## Lidcombe Town Centre Public Domain Plan Feedback

The following comments are based on material presented in the ‘Draft Public Domain Plan, Lidcombe Town Centre’ document, henceforth referred to as ‘The Plan’.

Map 4 - Marked up map from Open Street Map (Cycle Map layer) showing relative riding difficulty.  
See next page for notes.

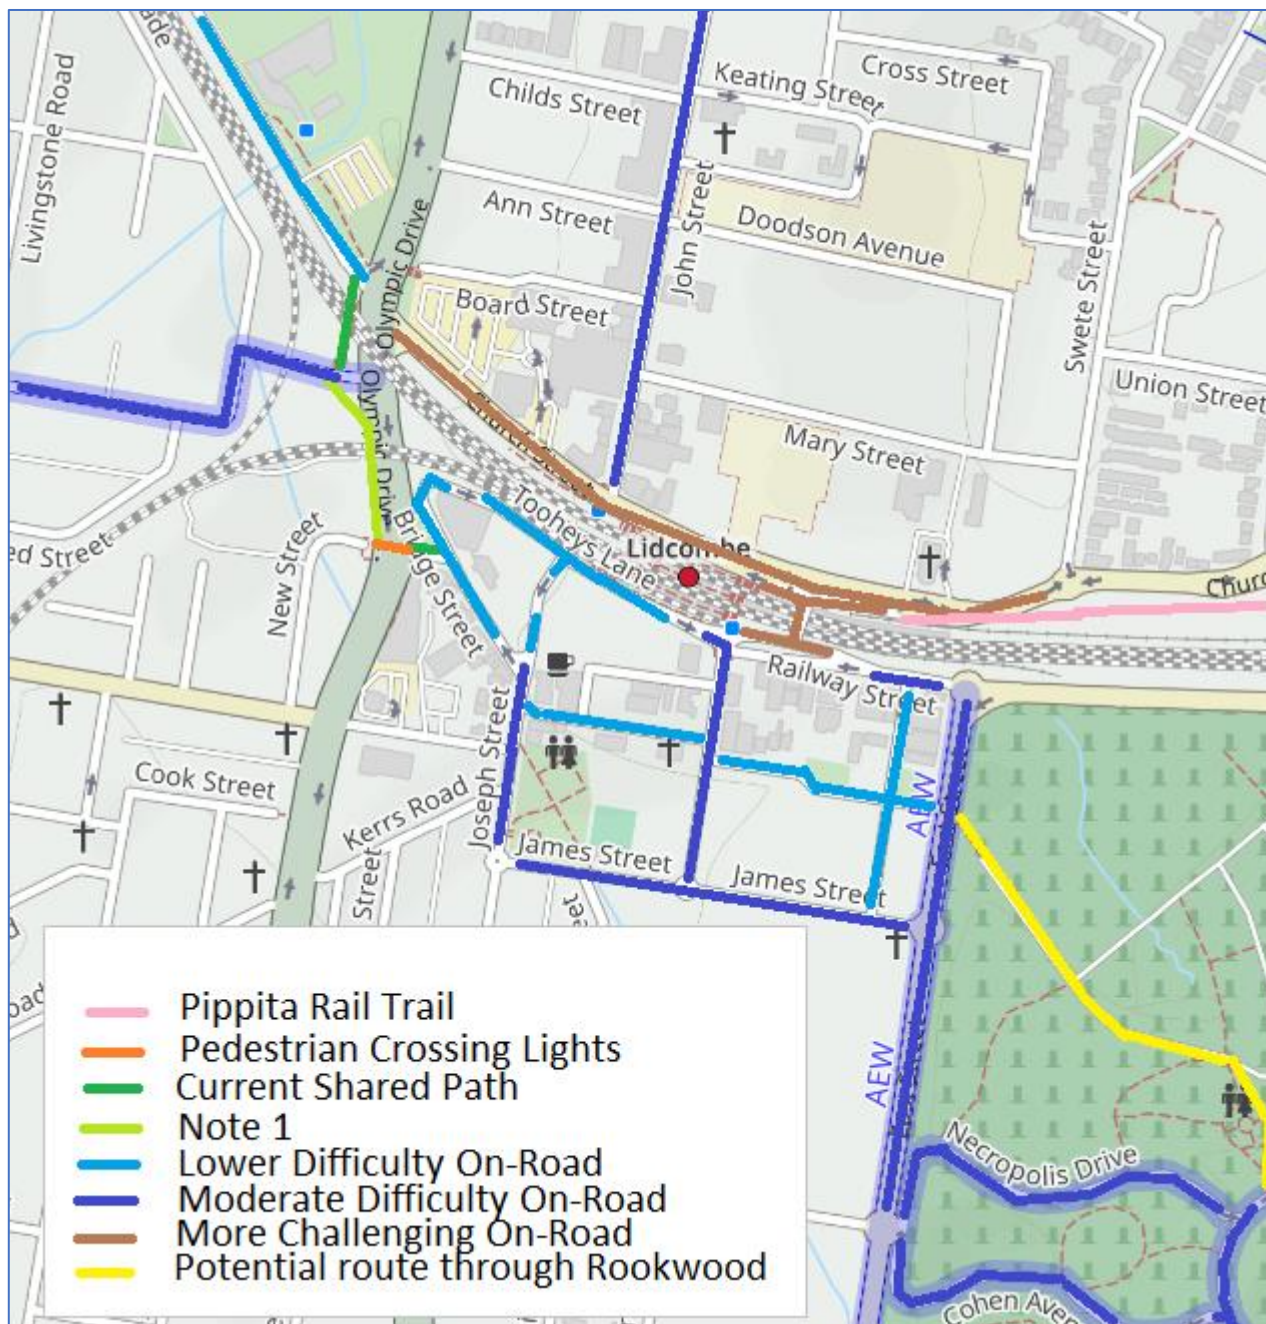
The 'More challenging On-Road' category involve roads that are either narrow or carry a reasonable amount of vehicular traffic and are on an incline. This assumes that the rider is using a non-assisted standard bike. The signalised intersection at Church St and Olympic Drive may also be intimidating for some riders.

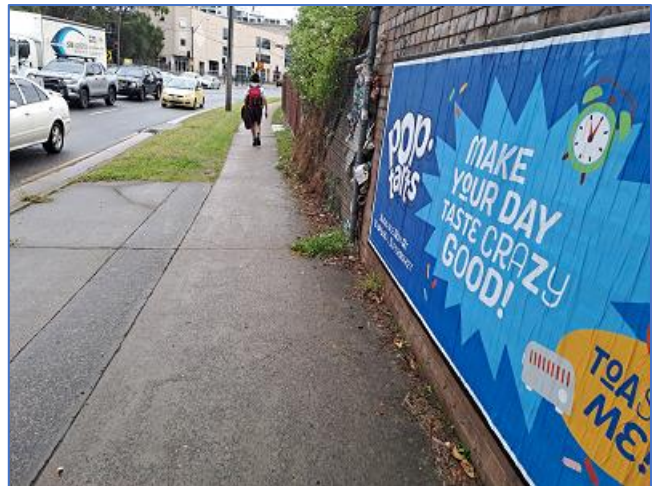
This section of pathway is defined in the RMS Cycleway Finder as shared path and on *Map 1* as an 'Active Transport Cycling Link'. However, around 130m of the 160m length is 'normal footpath' width with only around 30m (under the bridge) being of a width wide enough to be considered shared path. Apart from a sign on the northern side of Bridge Rd pointing towards Lidcombe there is no physical signage or markings to indicate that this is supposed to be a shared path.

- An additional step in marking this is a true active transport link would be to change the lanterns on the 'pedestrian crossing lights' crossing of Olympic Drive to pedestrian and cycling lanterns. I suspect this may be the domain of Transport for NSW rather than council. As identified on the above map, there is already a short stretch of shared path between the eastern side of the crossing and Bridge St.

- At the Church St end of the 'Current Shared Path' section under the main Western line (alongside Olympic Drive between Bridge and Church Streets), there's a 'Cyclists Dismount' sign due to the narrow ramp containing a sharp U-turn. The pedestrian crossing (or 'Beg') button to cross Church St from the south to north side is not readily accessible, being mounted on the traffic light pole facing the fence and away from the transit path of those using the ramp or steps.

*Damaged footpath from bridge turning left into Church St.*

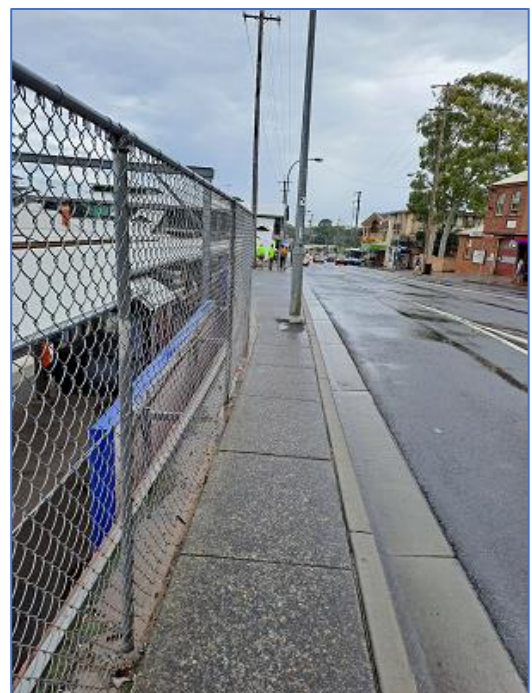
Narrow road with quite narrow (1.1m) footpath in parts, which may be challenging or dangerous to walk safely along if unable or unwilling to ride on the roadway. I doubt whether wheelchair or mobility scooter users would even attempt this crossing. The path surface is damaged in several places as shown in the photo to the right.

Currently, instead of a footpath on the southern (Railway St) approach to the crossing coming from the East, there is a ‘No Pedestrian Access Past This Point’ sign. If my understanding is correct, part of the Friends Park Precinct project appears to be the construction of a 1.2m wide path along this section which may at least improve access for pedestrians.

The bridge approaches are on an incline (more pronounced if approaching from the east along Church St) which some riders may find challenging. While this may not provide a barrier to the fitter riders or those on e-bikes, it certainly doesn’t appeal to everyone in the ‘8 to 80’ age range.

Bridge widening or road reconfiguration in this vicinity wouldn’t be easy or come cheaply but is the only viable option that I can see for reasonable active transport connectivity between both sides of the railway line.

Map showing location of points raised below

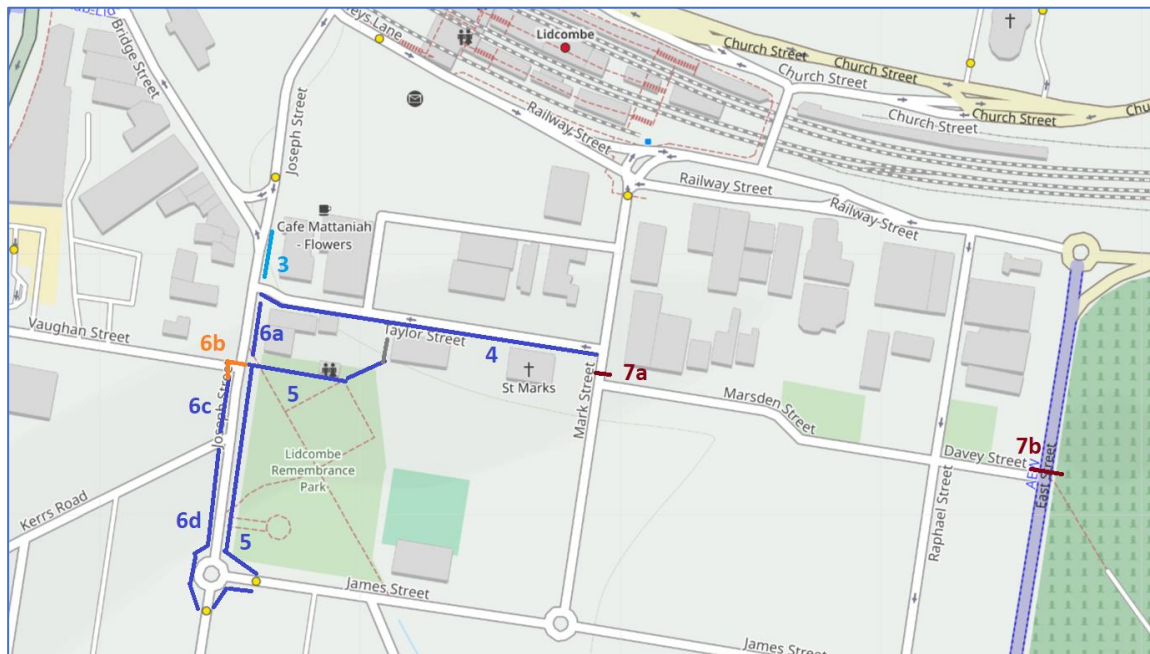
1. The aforementioned path along the western side of Olympic Drive needs work and money to bring it up to shared-path standard. This path appears to be geographically outside the scope of both the John St and Joseph St precincts.
2. The active transport link shown on *Map 1* from the Olympic Drive pedestrian crossing along Bridge St and Tooheys Lane into Railway Street is one way at present, heading west to east. Is there planned to be a contra-flow for cyclists? If not, there doesn't appear to have been any route marked for those heading east to west.

3. The current east west link on the southern side of the railway line from Mark St to the Olympic Drive pedestrian crossing is via Taylor St, Joseph St, and Bridge St. The right turn from Taylor into Joseph can be intimidating, crossing two lanes heading south on Joseph St. We would like consideration given to converting the eastern-most lane of Joseph St between Taylor St and Bridge St (green line on photo) to a contra-flow cycle lane.
4. We'd like council to consider converting the 2.5m wide footpath along the southern side of Taylor St into a shared path – ideally two way, but at least contra-flow to the one-way roadway. The effective width of the path is currently reduced by the presence of poles and a service box.

5. We believe there's an opportunity to build a shared path from the current small carpark off the south side of Taylor St through Remembrance Park, providing access to the Joseph/Vaughan St signalised intersection and James St pedestrian Crossing near the Joseph St roundabout.

6. As the above heat maps demonstrate, Kerrs Rd, with its signalised crossing of Olympic Drive, provides an important cycling corridor to the southwest of the town centre. We'd like to propose some additions which we believe could improve access for less confident riders to this important corridor.  
Given that a crossing of Joseph St opposite Remembrance Park isn't possible due to the proximity of the Vaughan St signalised intersection and James St roundabout, the following is suggested:

- a. Provide a route from Taylor St to the Joseph/Vaughan Streets signalised crossing – whether that be through Remembrance Park as above, and/or declare the 25m of reasonably wide path on the eastern side of Joseph St between Taylor St and Vaughan St lights as a shared path.

- b. Convert the pedestrian lanterns crossing Joseph and Vaughan Streets to combined pedestrian and cycling lanterns.
  - c. Declare the 30m of footpath along the western side of Joseph St between Vaughan St and Kerrs Rd as shared path.

- d. As a possible addition, declare the 75m of path along the western side of Joseph St from Kerrs Rd to the pedestrian crossing just south of the James St roundabout as shared path.

7. CAMWEST welcomes the proposal of Marsden/Davey Streets as a shared 10kmph zone. To encourage pedestrian and cyclist movement from the town centre into Rookwood Cemetery, we would encourage council to plan for:

- a. A pedestrian/cyclist crossing of Mark Street near Taylor Street and Marsden Street.
  - b. A traffic island or pedestrian/cyclist crossing of East St near the end of Davey St to facilitate crossing to the Rookwood Cemetery pedestrian gate. Several car parking spaces may need to be removed on the eastern side of East St to facilitate safe crossing.

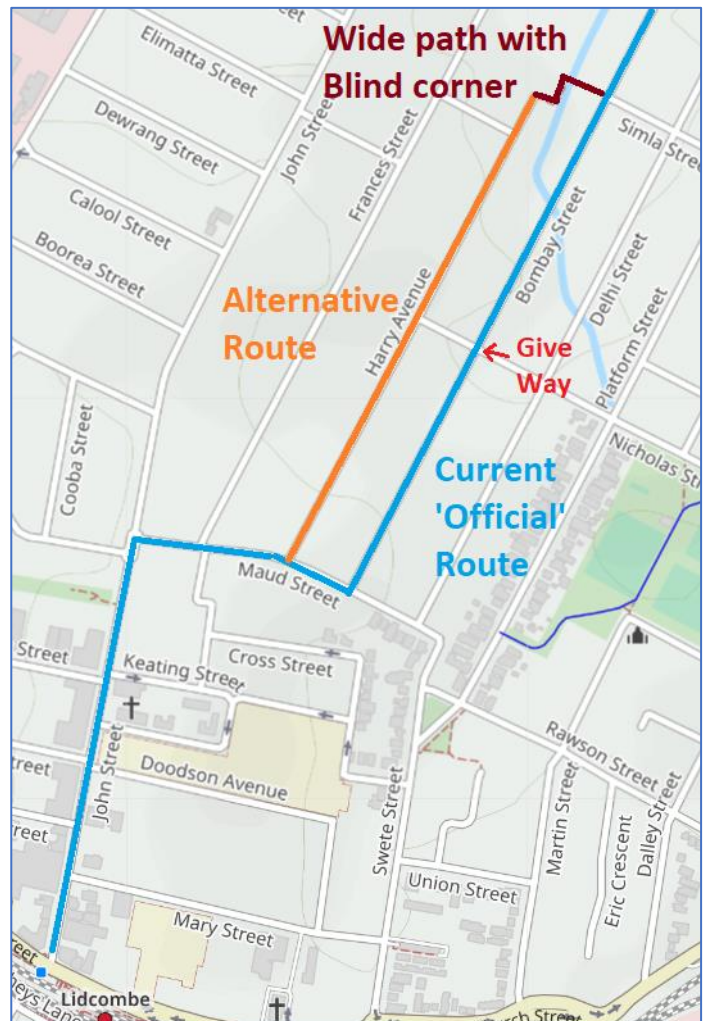
9. We feel that John St remains a challenge. We hope that the measures proposed assist in calming the traffic along this corridor.
10. We welcome the proposal of a 3m wide separated path along Mary St. However, given the relative unfriendliness of John St for inexperienced riders at present, harbour some doubts as to how well it will be patronised.
11. We would like to see more detail on the proposed Pippita Rail Trail route, particularly the section leading to the station along Church St.

12. Just outside the immediate precinct area, we would welcome any potential bridge crossing of Olympic Drive from Chadwick Reserve into Wyatt Park as briefly mentioned in The Plan. This could be a real boon for active transport in the area.

13. The following is outside the four precincts but shown on *Map 1*. It is raised here as a broader idea for consideration. Regarding the suggested on-road route from John St along Maude St and Bombay St towards Parramatta Rd and Sydney Olympic Park, my preferred route from Maude St is along Harry Ave (parallel to Bombay St) to the end of the road, then along a pathway around a blind corner, across the Haslems Ck tributary, and then to re-join Bombay St opposite Simla St. This may make a good route if the blind corner could be made safer. From my perspective, the advantages of using Harry Ave are that the road is quieter than Bombay St, and the 'Give Way' sign at Nicholas St can be avoided.
